Item ID: D2580-1 Accept *N900040100* Setup Start *NS1*
 Revision ID: Stop *NS2*
 Item Name: 205 Skidtube bent detail
 Start Date: 8/13/12 Start Qty: 4.00 *4* Cust Item ID:
 Required Date: 8/13/12 Req'd Qty: 4.00 *4* Customer:
 Reference:

DRAWING NO. REV. E
D2580 SHEET 1 OF 8
TITLE SCALE
205 SKIDTUBE ASSEMBLY NTS

DRAWING NO. D2580	TITLE 205 SKIDTUBE ASSEMBLY	REV. E	DART AEROSPACE LTD ENGINEERING ORDER		D.E.O. NO. D2580-E-1	SHEET NO. SHEET 1 OF 1	SCALE NTS
DRAWN <i>UP</i>	CHECKED <i>ASS</i>	MFG. APPR. <i>EC</i>	APPROVED <i>#</i>		DE APPR. <i>HA</i>		
DATE 11.12.13	DATE 11.12.13	DATE 11.12.13	DATE 11.12.13		DATE 11.12.13

CHANGE ALL C'BORED WELDED CROSSBOLT SPACERS TO SWAGED SPACERS

SECTION B-B, F-F, I-I
NOT TO SCALE

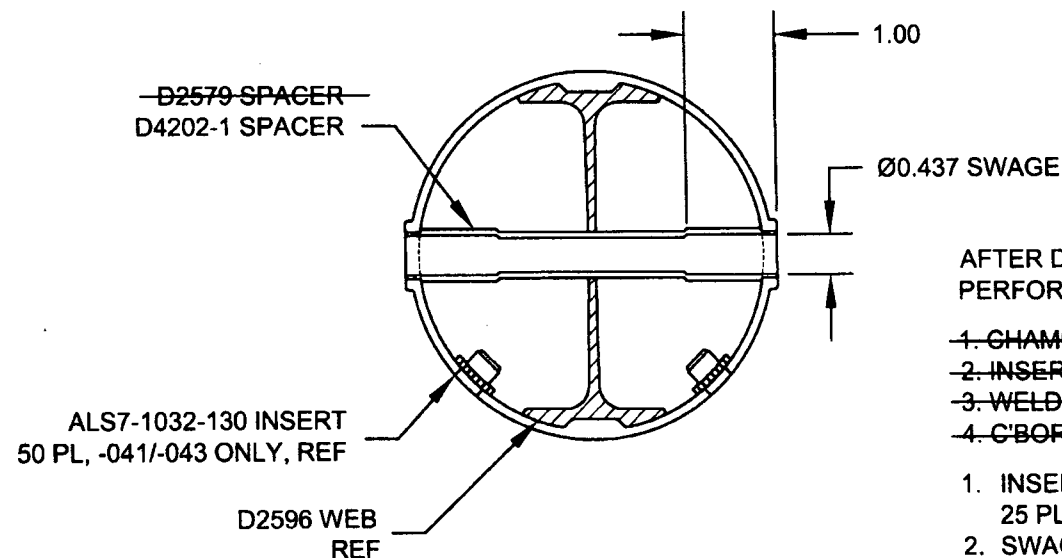
PARTS LIST IS AMENDED AS FOLLOWS:

WAS

QTY	QTY	QTY	PART NUMBER	DESCRIPTION
-041	-045	-047		
20	24	25	D2579	CROSS BOLT SPACER

IS

4		* D2579	CROSS BOLT SPACER
20	20	25	D4202-1	SPACER

SECTION B-B, SECTION F-F, & SECTION I-I ARE AMENDED AS FOLLOWS
FOR ALL HOLES THAT WERE ORIGINALLY C'BORED:

*** FOR -045 SKIDTUBE ONLY:**

WELD 4X D2579 SPACERS PER DWG
IN LOCATIONS MARKED "NO C'BORE".
REF SHEET 4 OF DWG.

AFTER DRILLING AND BENDING ASSEMBLY
PERFORM THE FOLLOWING FOR Ø0.508 HOLES ONLY:

- ~~1. CHAMFER HOLE 0.060 X 45°~~
- ~~2. INSERT D2579 SPACER (20 PLACES)~~
- ~~3. WELD INTO PLACE AND GRIND FLUSH~~
- ~~4. C'BORE D2579 SPACER TO Ø0.437 X 1.00 DEEP~~

1. INSERT D4202-1 SPACER, 20 PL (-041) OR 20 PL (-045) OR 25 PL (-047)
2. SWAGE TO Ø0.437 X 1.00 DEEP PER QSI 002
3. TRIM / GRIND FLUSH PER QSI 002
